THM 4L60-E/4L65-E "UPDATE HANDBOOK"

AUTOMATIC TRANSMISSION SERVICE GROUP

THM 4L60-E/4L65-E

1996 MANUAL VALVE AND VALVE BODY CASTING

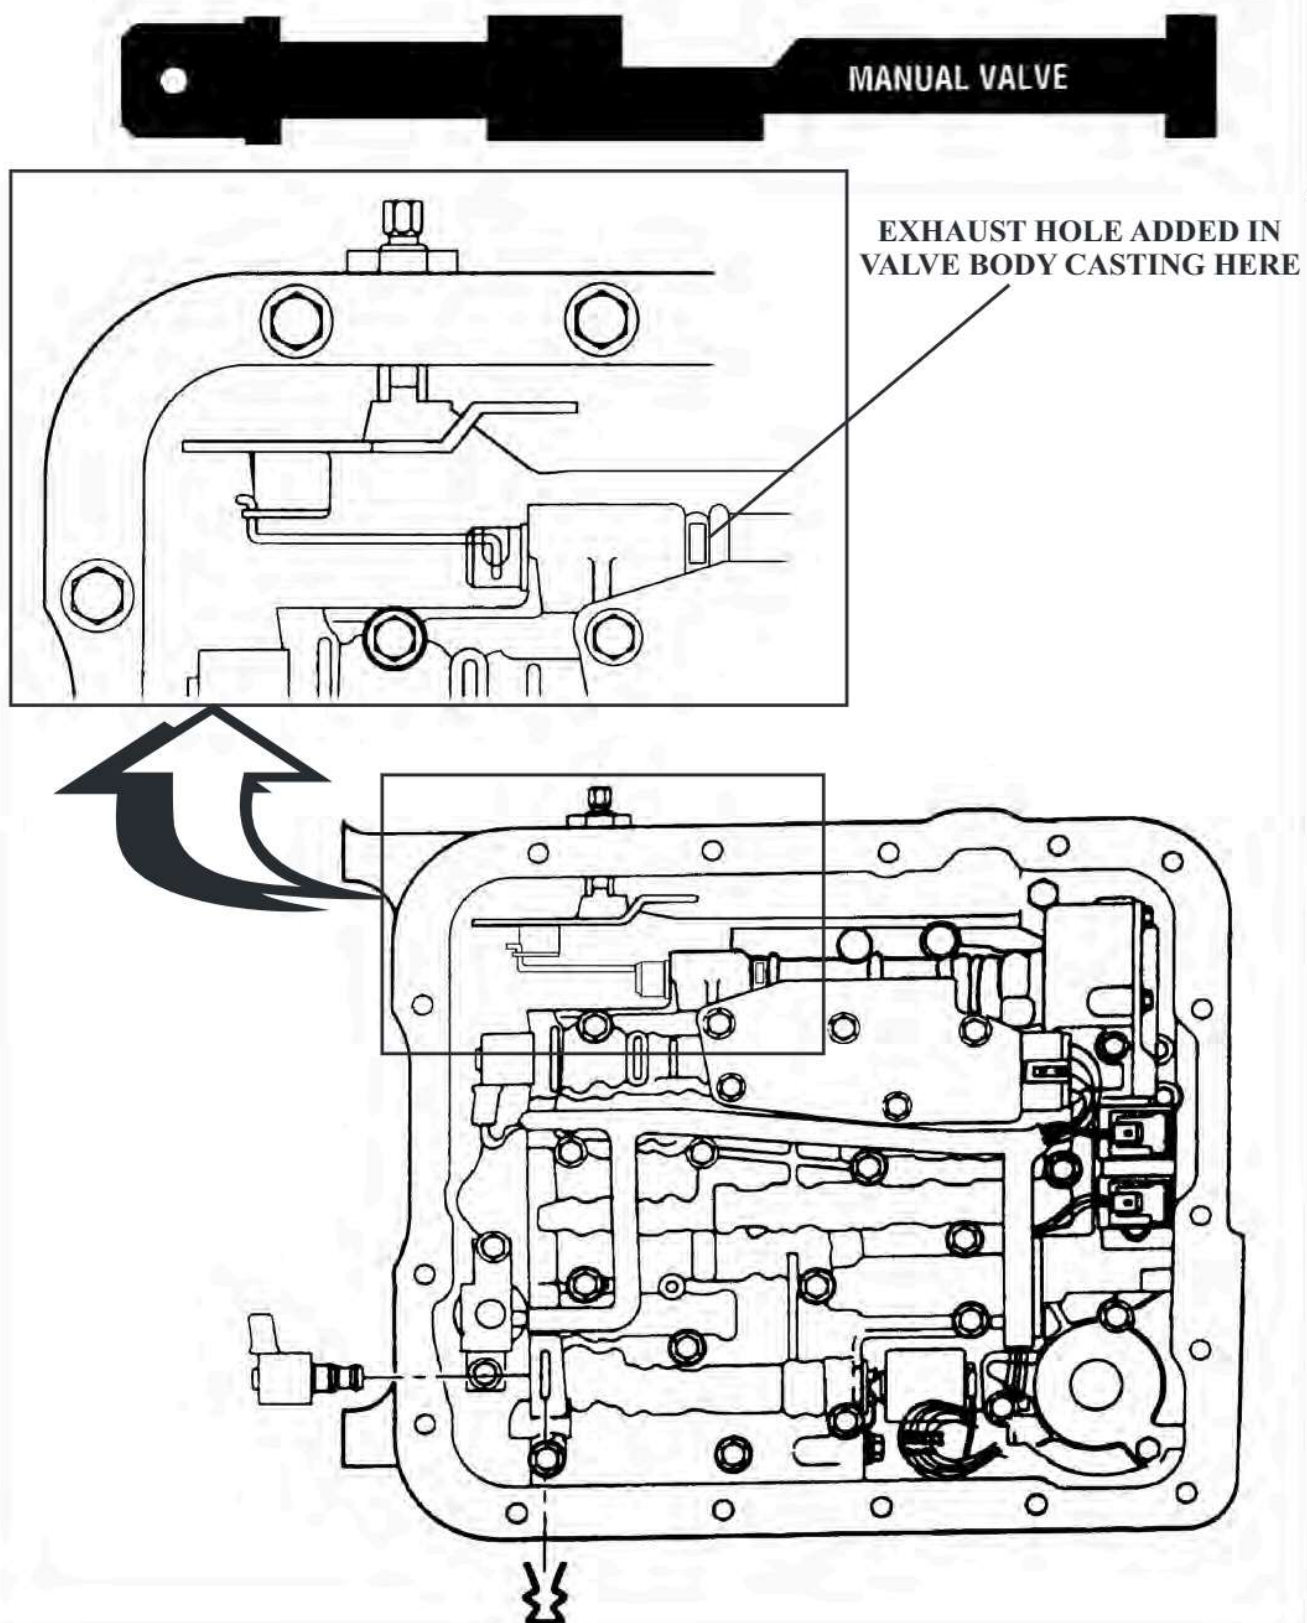
- (1) **VALVE BODY CASTING** - Added exhaust hole through the valve body casting in the manual valve bore, to exhaust Lo/Reverse clutch oil at a faster rate when the manual valve is in the Drive position. Refer to Figure 1 for 1995 models, and to Figure 2 for 1996 models.
- (2) **MANUAL VALVE** - Totally different design to accommodate the added exhaust hole in the valve body casting. Refer to Figure 1 for 1995 models, and to Figure 2 for 1996 models.

Figure 1

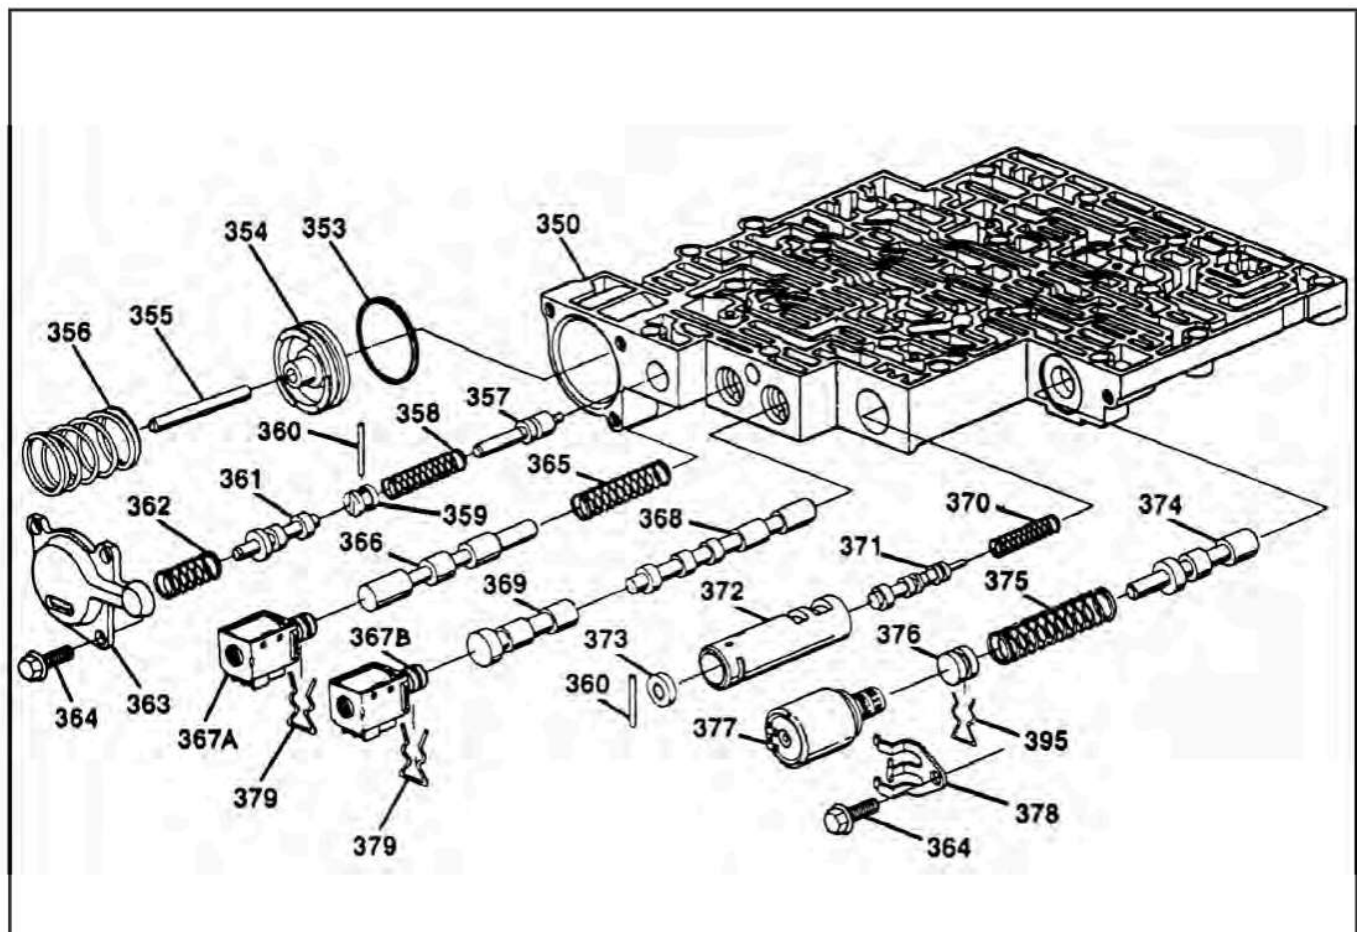
CORRECTION: There is now available a new calibration service package consisting of a 1-2 accumulator valve, valve spring, and 1-2 accumulator valve bushing for the valve body. These are items 370, 371, and 372, as shown in Figure 1 below. This new service package is available under OEM part number 24202698.

Figure 1

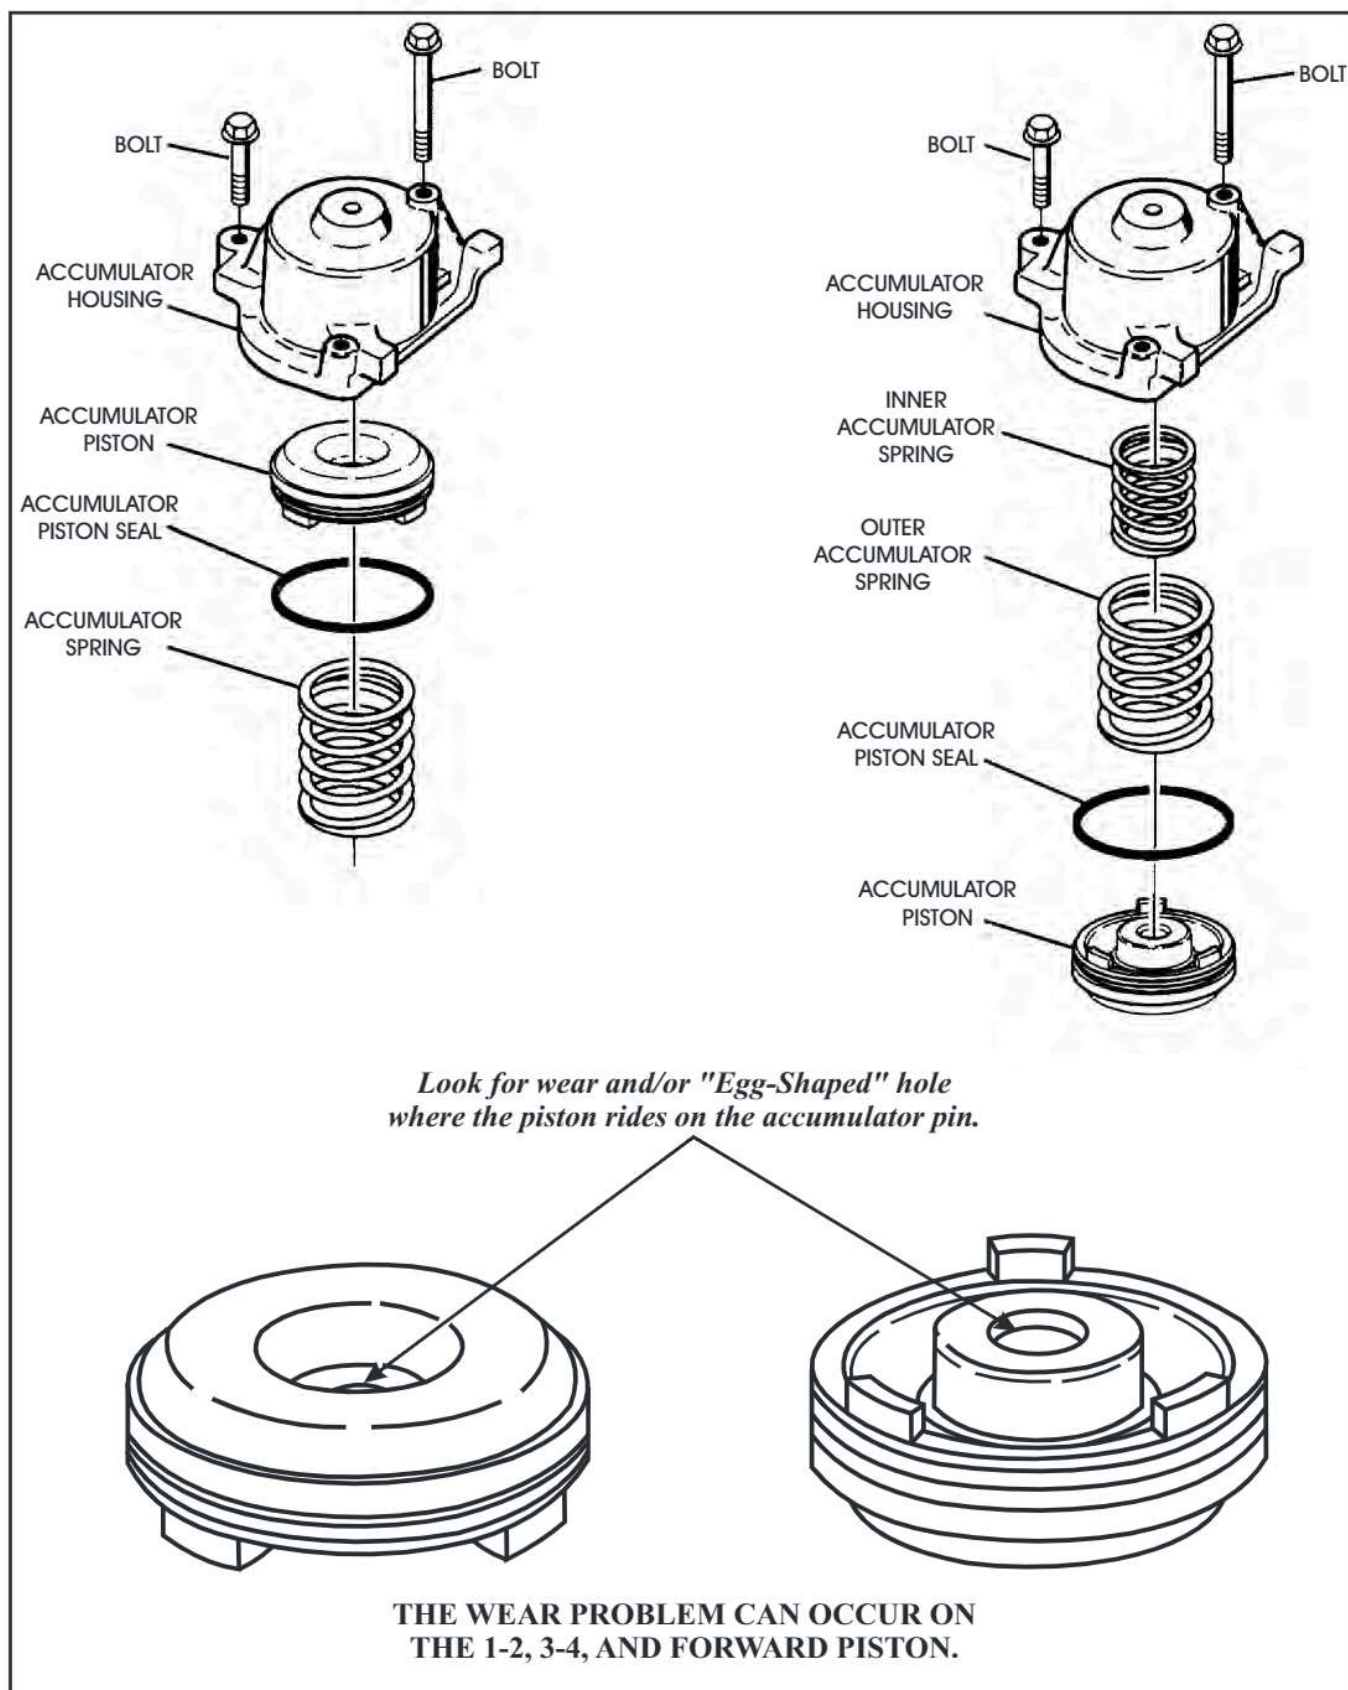
CAUSE: The cause may be, a worn accumulator piston pin bore (See Figure 1).

CORRECTION: Replace the accumulator piston with the proper part number from "Service Information" as shown below.

3-4 CLUTCH LINED AND STEEL PLATES

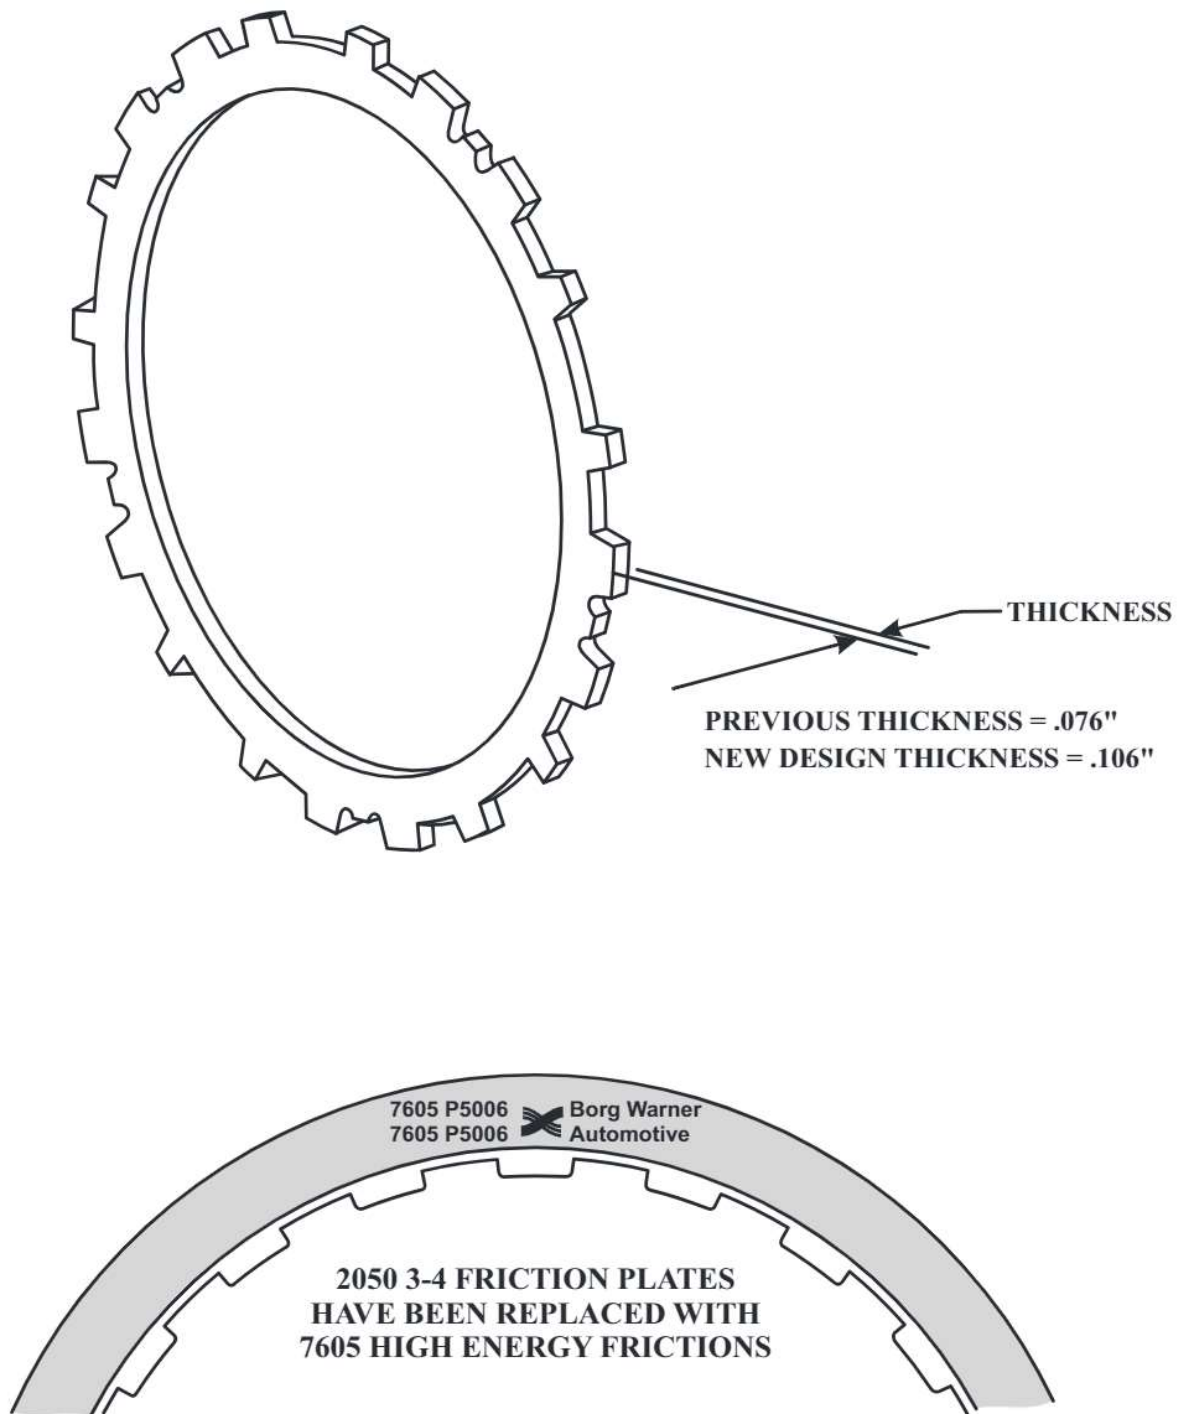
1. New design 3-4 Apply Ring with shorter legs.
2. New design one piece 3-4 Apply Plate.
3. New Design .106" thick 3-4 Steel Plates, 5 required (See Figure 1).
4. New design high energy 3-4 Friction Plates, 6 required (See Figure 1).
5. New design 3-4 Selective Backing Plate, as they are thinner.
6. Re-install the 3-4 Load Release Springs in the late design stack-up (See Figure 2).
7. Ensure that you have .050"-.070" clutch clearance.

Figure 1

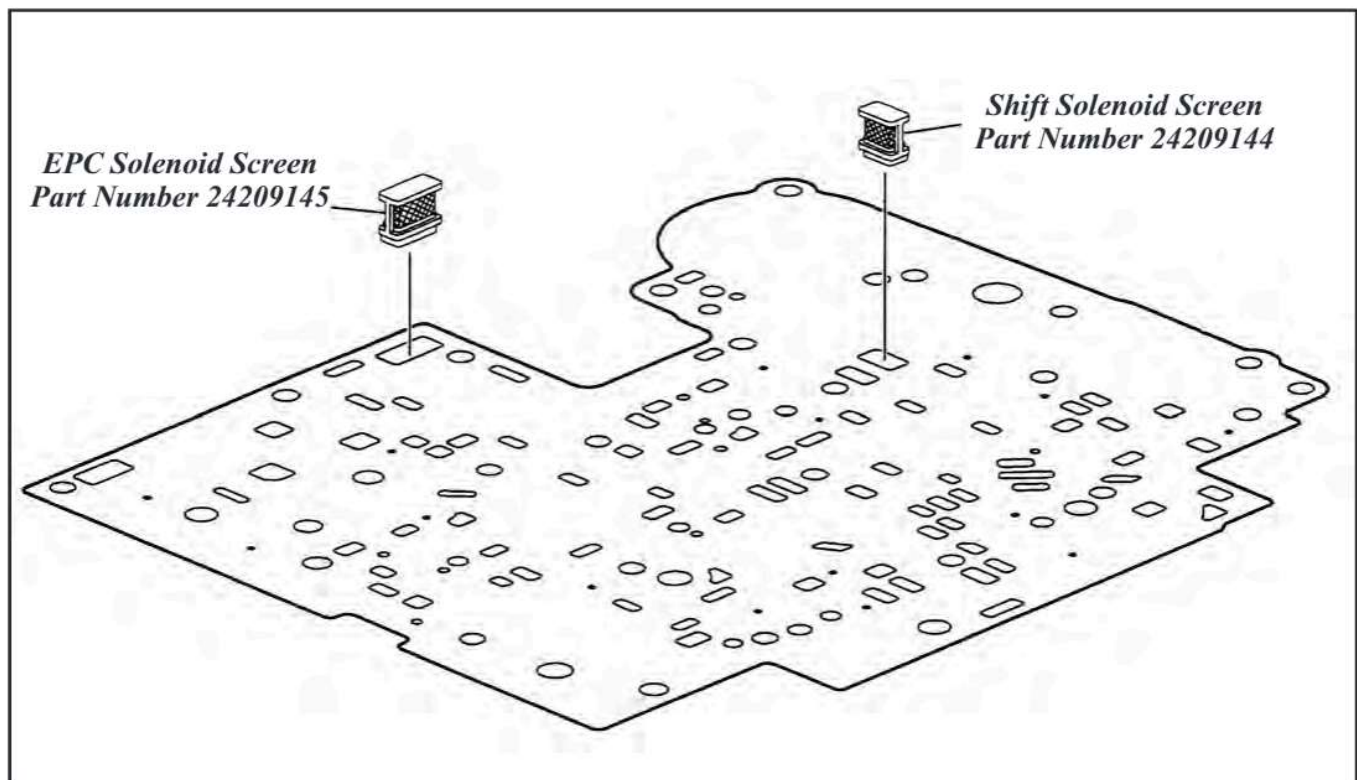
CORRECTION: Replace both screens in the spacer plate as shown in Figure 1, with the part numbers listed below. These **new part numbers** are screens with a larger micron screen that will pass more oil easier.

Figure 1

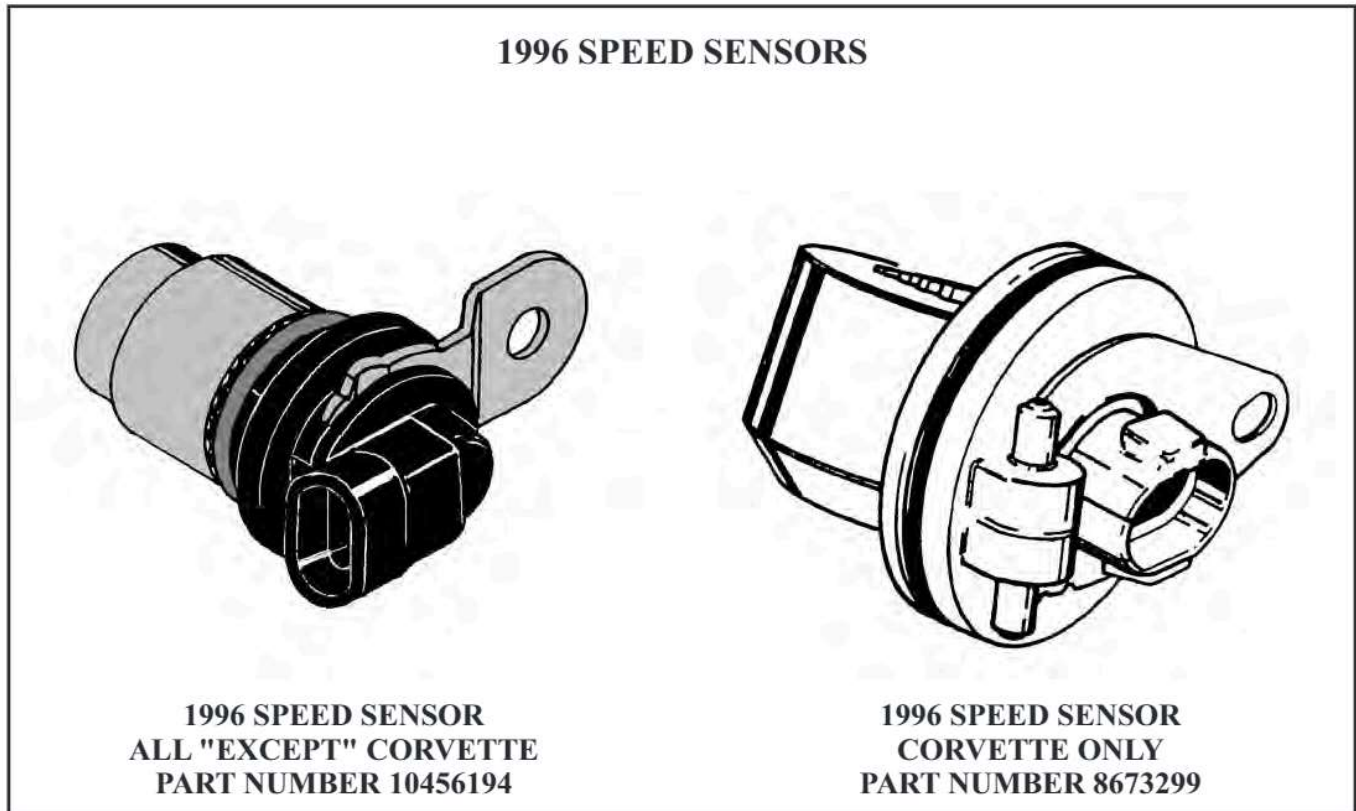
CHANGE: Beginning at the start of production for 1996 models, some THM 4L60-E transmissions were built with a new design Output Shaft Speed Sensor, as shown in Figure 1. Corvette models will be the only vehicle that will continue to use the previous design speed sensor, as shown in Figure 1.

- (1) EXTENSION HOUSING - New casting with smaller speed sensor bore diameter, to accept the new design Output Shaft Speed Sensor, as shown in Figure 1.

Figure 1

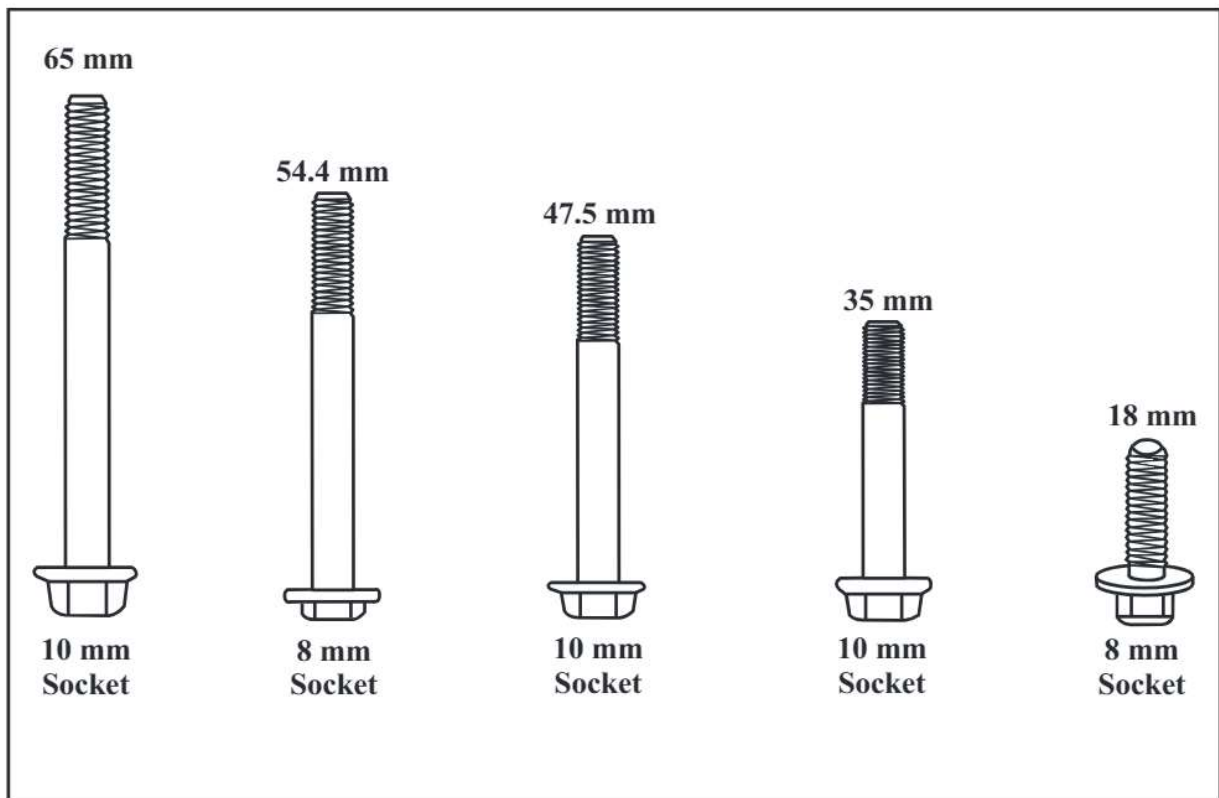
CAUSE: There are different length valve body bolts which can be easily mis-positioned (See Figure 1). A **common** error is placing a 54.4 millimeter length bolt into a location designed for a 47.5 millimeter length bolt (See Figure 2). The mis-located bolt will extend into the barrel of the case and into the sun shell. The bolt now being screwed into the sun shell inhibits the rotation of the shell causing the above complaint.

CORRECTION: Relocate the necessary valve body bolts to their proper location. Use figure 3 to locate the proper positions for the 47.5 and 54.4 millimeter bolt lengths. In severe cases, it may be necessary to remove the transmission in order to replace the damaged sun shell.
